Site Address: 2830 27TH ST SAC

Re **Investigation of Settlement Distress - Repair Specifications Report, Revised**  
Insured: Ron and Judith Paulet  
Claim Number: 02-042-6767  
Date of Loss: 01/10/98  
Address: 2830 27th Street, Sacramento, CA 95818  
Date of Assignment: 03/13/98  
Date of Inspection: 03/24/98  
Our File Number: 980343

**Second Revised Recommendations for Repair (Plan "C")**

REPAIR PLAN - REVISED

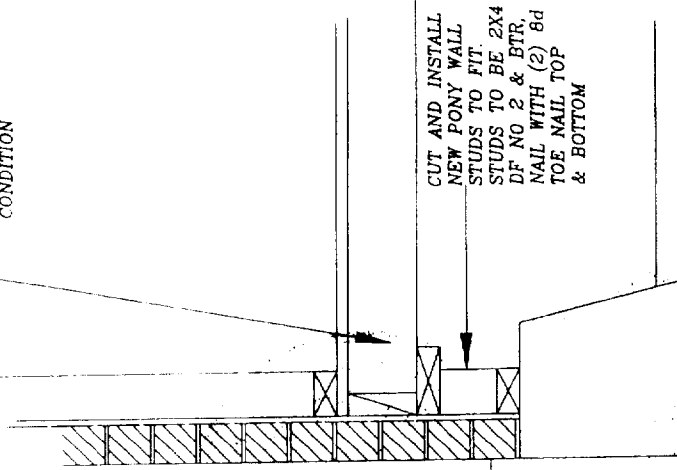
REPAIR HARDWOOD FLOOR HERE

PERFORM COSMETIC LEVELING OF THE HOUSE ALONG THE CROSS-HATCHED PERIMETER PER DETAIL A, TYPICAL.

REMOVE AND REPLACE DAMAGED BRICK VENEER

REMOVE AND REPLACE CONCRETE PATIO

REMOVE AND REPLACE CONC STEPS

PROVIDE NEW 24" X 24" X 12" CONCRETE FOOTINGS FOR EXISTING PATIO COVER
